## Product Change Notice (PCN)

**Subject:** Change Shipping Media on Select Package

Renesas is converting shipping media from Tube to Tray on package TSOP-44. The current shipping media in Reel remains unchanged.

**Appendix B - Shipping Tray Comparison**

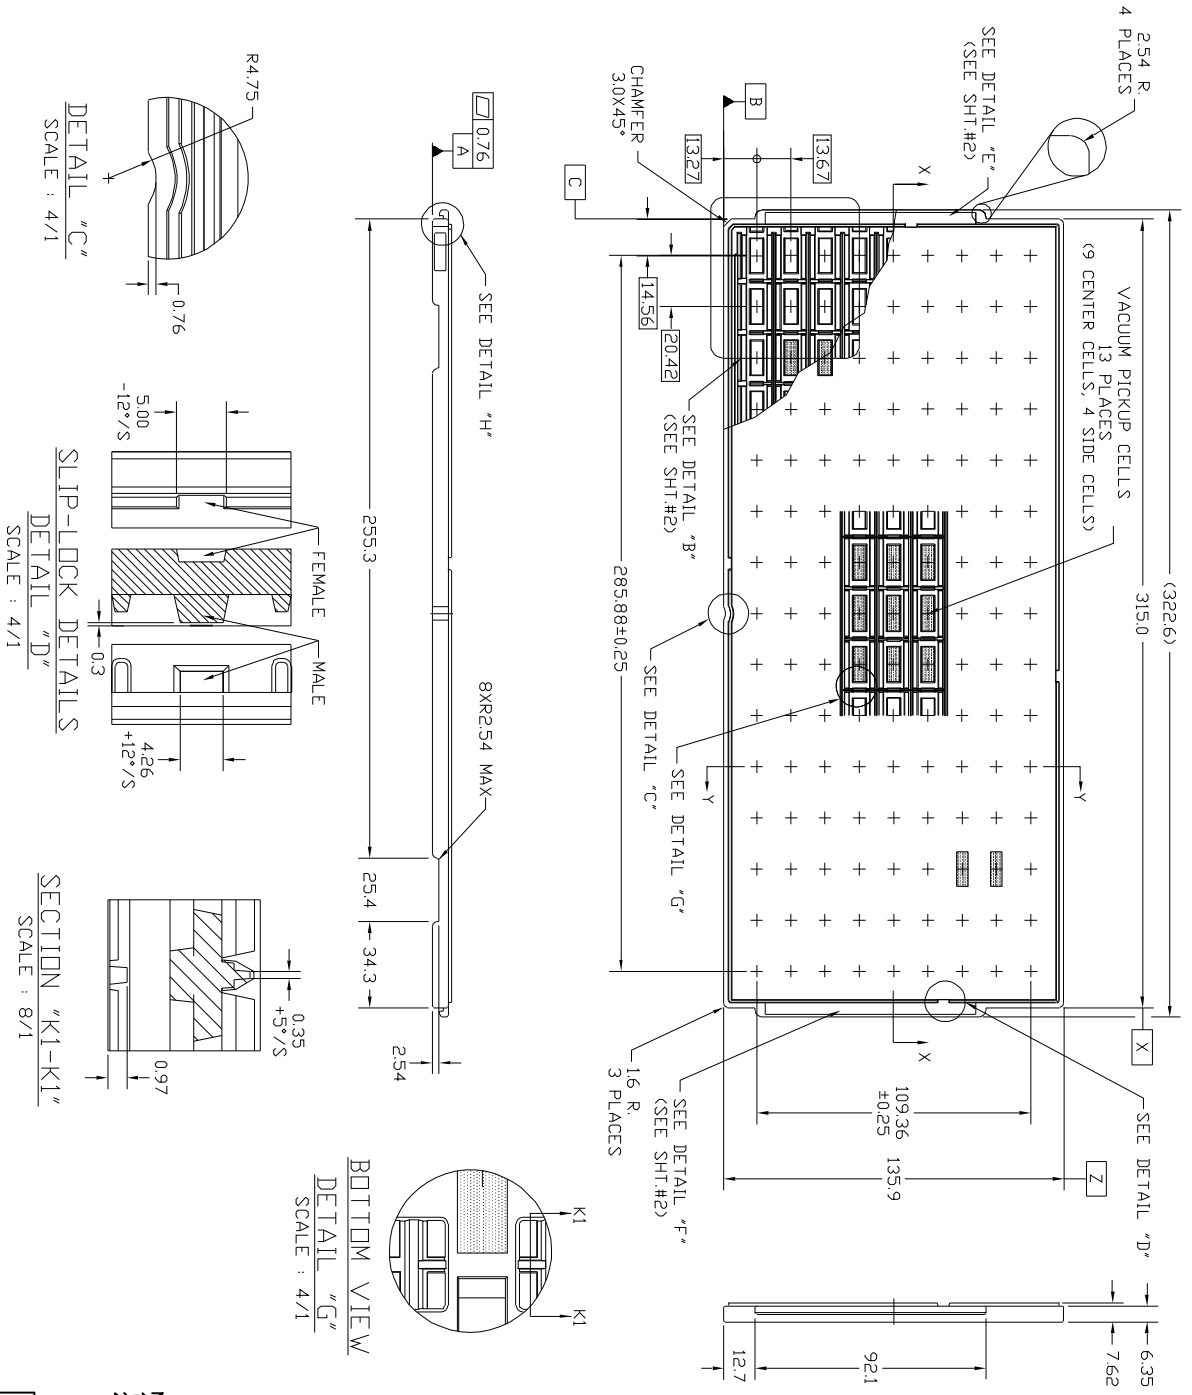
An Industrial standard JEDEC shipping tray will be introduced. In addition, one of the Orderable Part# that is presently ship in Tray (Tray part# 124-4725-119) will convert to the new Tray (New Tray part# TR142050). The MOQ and FOI in Tray shipment shall change to 135 units. Refer Appendix A and Appendix B for more information.

Descriptions	Current (Shipping Tray, part# 124-4725-119 )	New (Shipping Tray, part# TR142050)
Supplier	DAEWON	DAEWON
Tray Material	MPPO	MPPO
Tray Matrix	8x12	9x15
Units Per Tray	96	135
Row Pitch	15.16 mm	13.67 mm
Colum Pitch	25.50 mm	20.42 mm
